Technical Service Bulletin: tsb100212

Released Date: 02-Jul-2003

Revised Cylinder Head Gasket

Figure 1, QSK19-profile

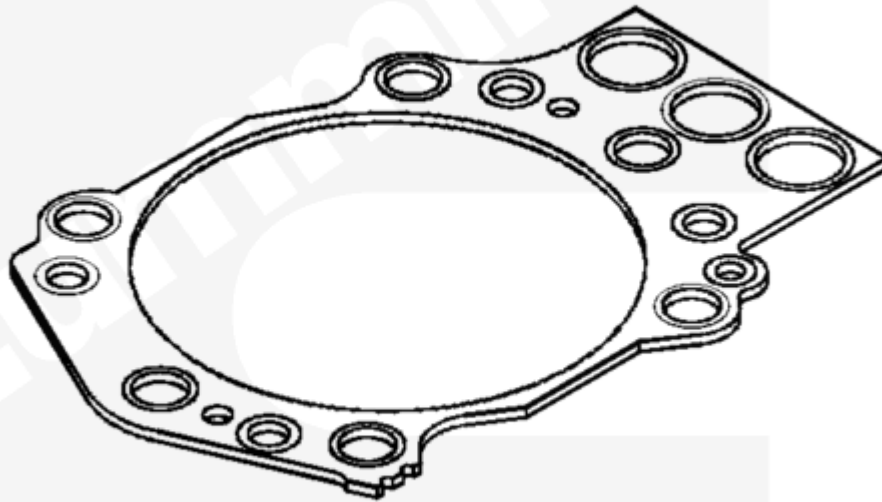
The QSK19-profile gasket, Part Number 3634664 (3634788 oversize), is pictured in Figure 1 below. The coolant and oil seals are edge moulded to this gasket.

- The QSK19-profile gasket (Figure 1) has a single oblong hole surrounding all three push tubes. The overall length on the push tube end of the QSK19-profile gasket is approximately 2 mm [.08 in] longer than the K-profile gasket, causing the edge of the gasket to protrude beyond the edge of the cylinder head.
- The K-profile gasket has individual holes around each push tube.

Use the QSK19-profile gasket if the mating surface of the block and head are refreshed during repair, or if the cylinder head gasket is being replaced.

Use the K-profile gasket when the mating surface of the cylinder block and head are **not** refreshed during repair, or if a K-profile gasket is being replaced.

Field experience has found, in some cases, the K-profile gasket provides better sealing characteristics than the QSK19-profile gasket on worn K19/38/50 cylinder blocks. A K-profile gasket can **not** be used on a QSK19 cylinder block.

Figure 3, QSK19-profile Steel Bridge Enhancement

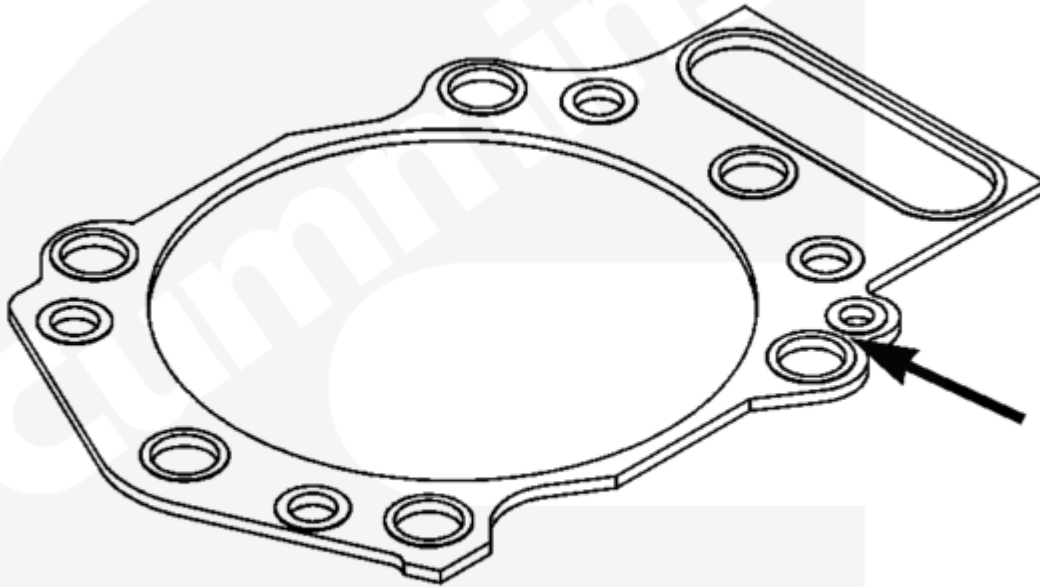
As a product improvement, a steel bridge has been added to the gasket carrier between one of the head bolt drillings and the high pressure oil passage. The location of this durability enhancement is shown by the arrow in Figure 3 above.

The new QSK19-profile cylinder head gasket, Part Number 3634664 was implemented in production at the following dates and ESN firsts.

Engine	Date	ESN
K19/QSK19	12-12-2002	37206052
K38/50	01-27-2003	33153376

Figure 4, Oversize Gasket Notch

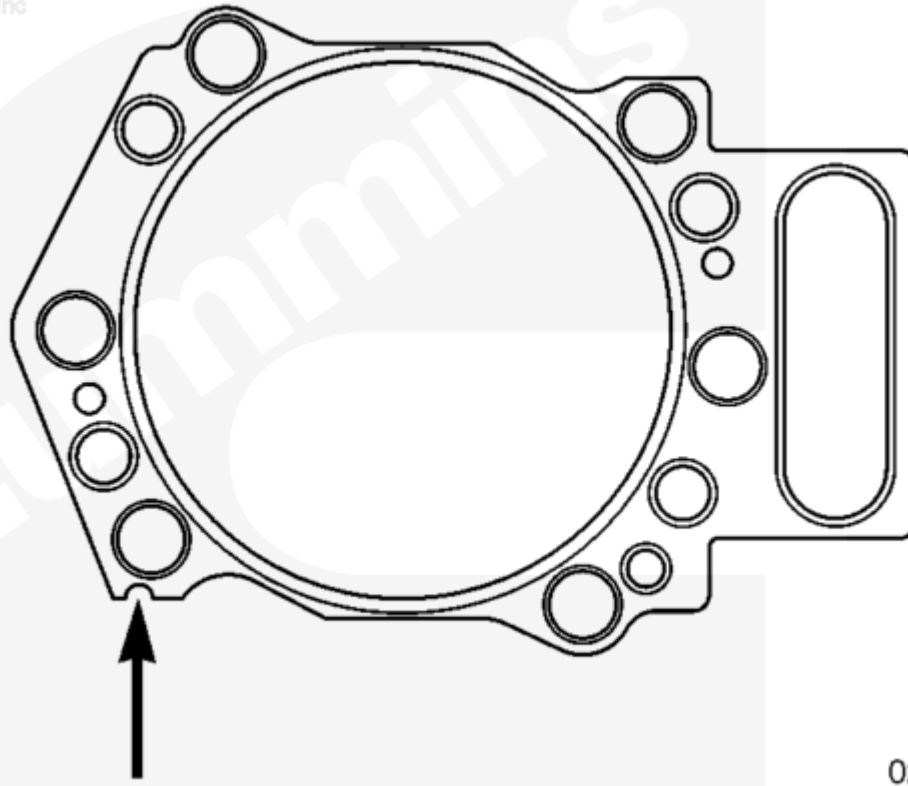
An oversize QSK19-profile cylinder head gasket, Part Number 3634788 has been developed and is now ready for service.

This gasket is 0.51 mm [0.02 in] thicker than the standard gasket and allows for greater machining of the cylinder block deck for rebuild or overhaul. A notch in the steel carrier to denotes the gasket as a service oversized gasket, shown by the arrow in Figure 4 above.
